CDM: Recommendation Form for Small Scale Methodologies (version 01)
(To be used for presenting questions/proposals/amendments to the simplified methodologies for small-scale CDM project activity categories)

Date of SSC WG meeting:	15–18 June 2010, SSC WG 26
Title/Subject (give a small title or specify the subject of your submission, maximum 200 characters):	Clarification on the treatment of waste gas recovery as new initiative or an incremental gain in existing practice under para 3 of AMS-III.Q
Indicative methodology to which your submission relates (refer the items of Appendix B of the Simplified Modalities and Procedures), if applicable.	AMS-III.Q (Version 03) “Waste Energy Recovery (gas/heat/pressure) Projects”
Name of the authors of the query:	Susanta Moitra Institution: Jayaswal Neco Industries Limited susanta.moitra@necoindia.com

SSC-Submission number	SSC_413
Date when the form was received at UNFCCC secretariat	18 June 2010
Date of transmission to the EB	18 June 2010
Date of posting in the UNFCCC CDM web site	18 June 2010

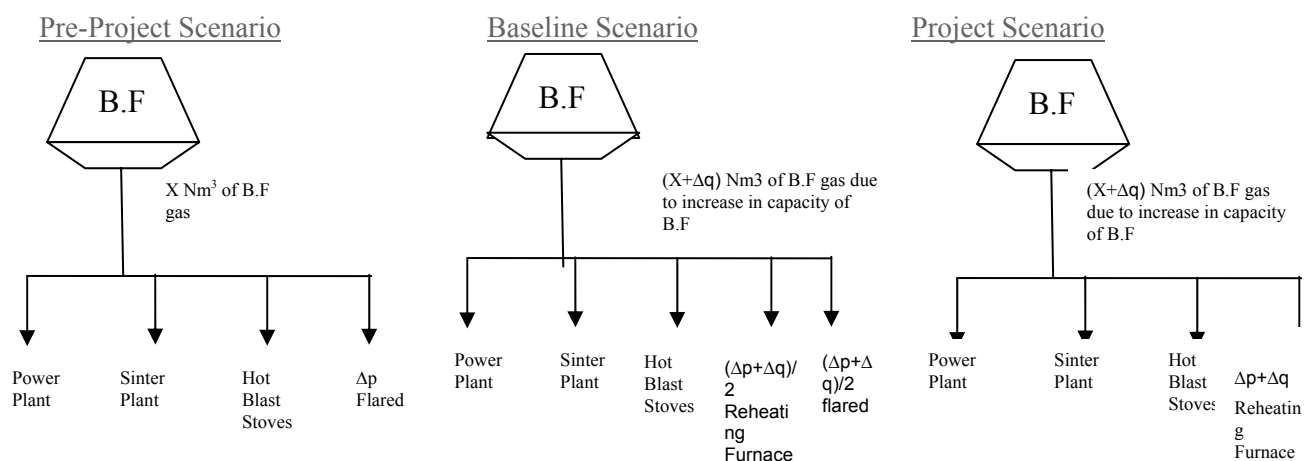
The description of the project activity concerned is described through the diagram below:

In the pre-project scenario the BFG coming out of the blast furnace (existing facility) was recovered and utilized subsequently in the power plant, sinter plant and the hot blast stoves and surplus portion (Δp Nm³) of the waste gas had no other utilization within the steel plant and was flared.

The capacity of the Blast Furnace (existing facility) was increased and the surplus waste gas which

increased to $(\Delta p + \Delta q)$ Nm³ had no point of utilization within the steel plant and was flared. Historical data (flaring record of $(\Delta p + \Delta q)$ Nm³ for two months before the commissioning of the rolling mill as well as three years prior to the capacity augmentation of the blast furnace i.e flaring record of Δp Nm³) supporting the same before the implementation of the rolling mill is available.

However the PP came up with the installation of reheating furnaces in the Bar Mill and the Wire Rod Mill and started utilizing the entire $(\Delta p + \Delta q)$ Nm³ amount of BFG which had no point of utilization within the steel plant as a process heat with the help of special type of regenerative burners.

1. Whether the recovery of waste gas is a new initiative or an incremental gain in existing practice?
2. Whether the entire BFG is a by product (according to definition by ACM0012) or part of the BFG which is available after the expansion of the blast furnace is a by product?

It is understood from the submission that in the absence of the regenerative burners (project activity), a portion of BFG would have been flared as the re-heating furnace could only use 50% of BFG and 50% of fuel oil (in energy basis) to produce heat energy. The SSC WG is of the opinion the proposed baseline scenario is hypothetical and argument is based on consultant's specification, and not on historical data (prevailing practice).

It is also understood that the additional Δq amount of BFG is as a result of capacity expansion and/or new installation at the facilities of the industry. It should be noted that AMS-III.Q does not cover capacity expansion/Greenfield project activities where a detailed procedure to determine baseline would be needed to demonstrate that in the absence of the project activity, the waste gas would be vented-off. Consequently AMS-III.Q is not applicable to the project case. The SSC WG evaluated that the procedures needed to cover these situations will make the methodology complicated and a simplified small-scale methodology may not provide the right framework for the kind of technology/measure being addressed by the proposed project taking into account the board guidance (EB 47, paragraph 58).

The project proponent may explore applying ACM0012 for the project case.
